**City of West Linn**  
**PRE-APPLICATION CONFERENCE MEETING**  
**July 3, 2008**

SUBJECT: 11-lot subdivision at 1329-1335 Willamette Falls Drive.

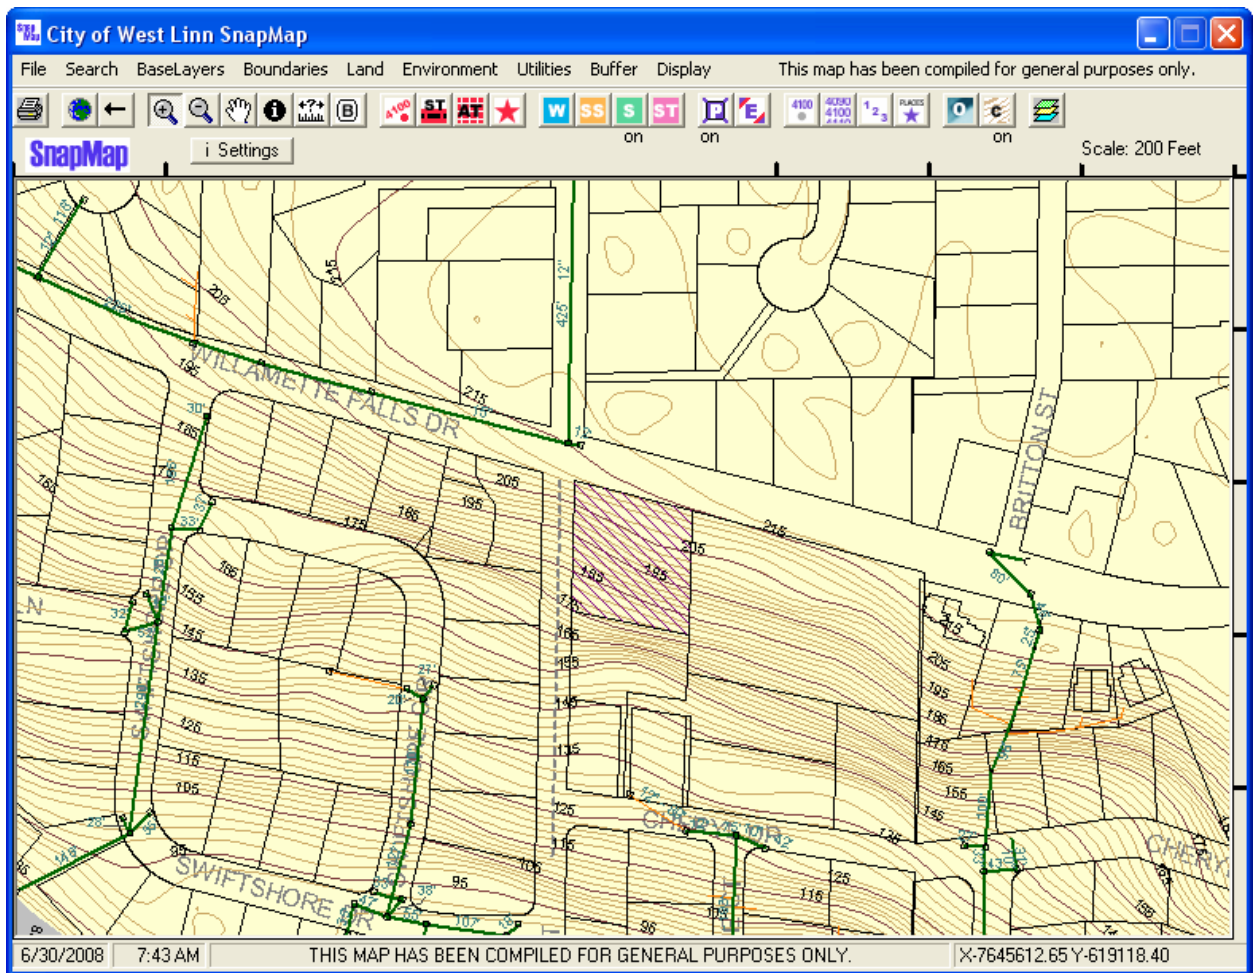
19<sup>th</sup> Street is currently an unimproved right-of-way. The City Transportation Master Plan indicates that 19<sup>th</sup> Street is a Neighborhood Route. The right-of-way for a neighborhood route varies from 48'-52'-56' depended upon whether or not on-street parking is required.

*Currently the unimproved right-of-way is 40' wide. Dedication may be required depended whether or not development will construct an access onto 19<sup>th</sup> Street.*

*If the applicant decides to construct an access onto 19<sup>th</sup> Street, applicant shall be required providing street improvement that shall be adequate to handle the two way traffics.*

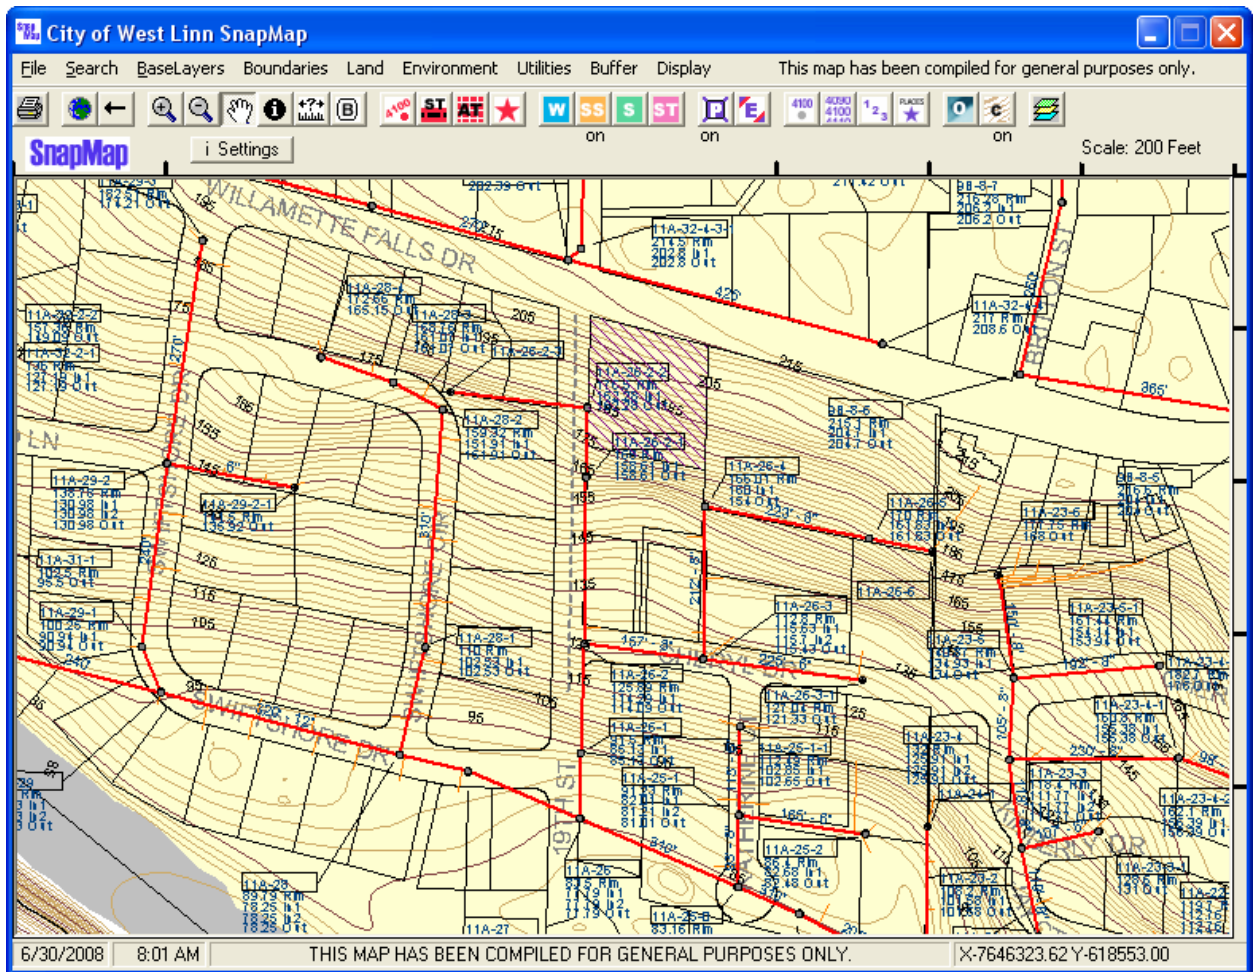
From the City GIS map, there is not storm drainage system along the project frontage on both Willamette Falls Drive and unimproved 19<sup>th</sup> Street.

***Possible connection is on Cheryl Drive but this will require request of easement on the neighboring property or running the storm line in the unimproved 19<sup>th</sup> Street ROW down to and connecting to Cheryl Drive.***

Street run-off along the project frontage on both Willamette Falls Drive and 19<sup>th</sup> Street shall be collected, treated and detained before discharging to the public storm system.

On-site run-off shall also be collected, treated and detained before discharging to the public storm system.

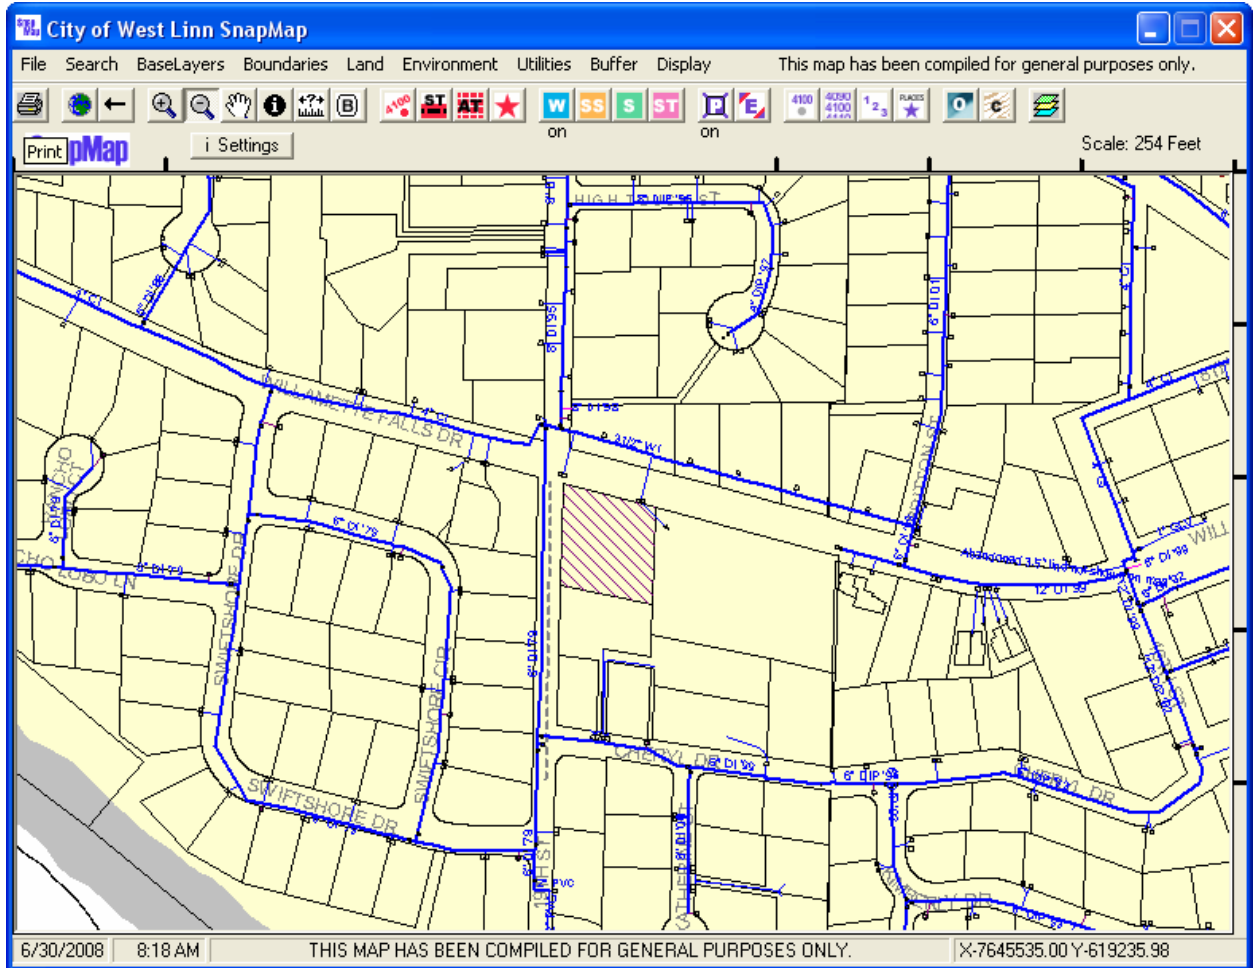
From the City GIS snap map, there are existing public water mains surrounding the proposed project site for possible connection.

***Existing water meters shall be removed and plugged.***
